UNITED STATES PATENT AND TRADEMARK OFFICE

APPLICATION NO.	FILING DATE	FIRST NAMED INVENTOR	ATTORNEY DOCKET NO.	CONFIRMATION NO.
10/583,901	11/03/2008	Angelo Schiavon	00758.1537USWO	7365
23552	7590	03/25/2011		
MERCHANT & GOULD PC P.O. BOX 2903 MINNEAPOLIS, MN 55402-0903			EXAMINER MENON, KRISHNAN S	
			ART UNIT	PAPER NUMBER
			1777	
			MAIL DATE	DELIVERY MODE
			03/25/2011	PAPER

Office Action Summary	Application No. 10/583,901	Applicant(s) SCHIAVON ET AL.	
	Examiner Krishnan S. Menon	Art Unit 1777

DETAILED ACTION

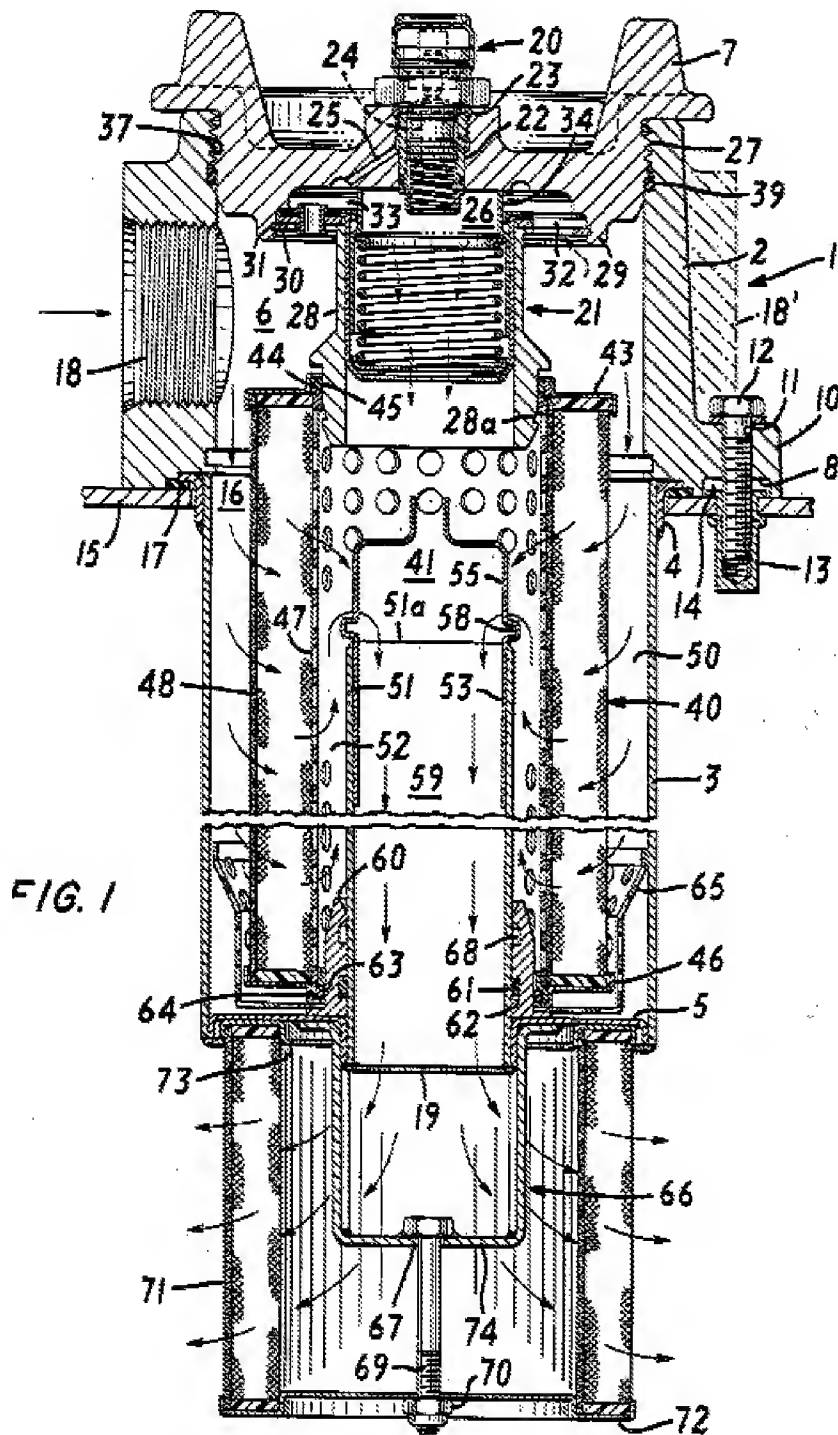
1. Claim 23 is rejected under 35 U.S.C. 103(a) as being unpatentable over Cooper (US 4,133,763).

Cooper's fig 1 is copied herein. Cooper teaches a primary filter element (48), secondary (bypass) filter element (71), an end cap (5) there-between, the end cap having a tube (51/53) projected within and parallel to the axis, a seal (61) in a seal member surrounding the tube, a perforated tubular support within the primary filter, a second end cap at the opposite end of the primary filter (43) which has a tube extending from it for connection to the housing top, and having a seal (45) on a seal plane which is having a slight angle as can be visualized from (28a). The structural member (66) is received in a radial slot defined by the first end cap and the filter end (73).

Cooper does not teach the seal (45) at the second end cap as being at an angle to the axis. However, providing an appropriate draft angle for the seal plane at (28a) would be within the skill of one of ordinary skill in the art. In *Gardner v. TEC Systems, Inc.*, 725 F.2d 1338, 220 USPQ 777 (Fed. Cir. 1984), cert. denied, 469 U.S. 830, 225 USPQ 232 (1984), the Federal Circuit held that, where the only difference between the prior art and the claims was a recitation of relative dimensions of the claimed device and a device having the claimed relative dimensions would not perform differently than the prior art device, the claimed device was not patentably distinct from the prior art device. In *re Dailey*, 357 F.2d 669, 149 USPQ 47 (CCPA 1966) (The court held that the configuration of the claimed disposable plastic nursing container was a matter of choice which a person of ordinary skill in the art would have found obvious absent persuasive evidence that the particular configuration of the claimed container was significant.).
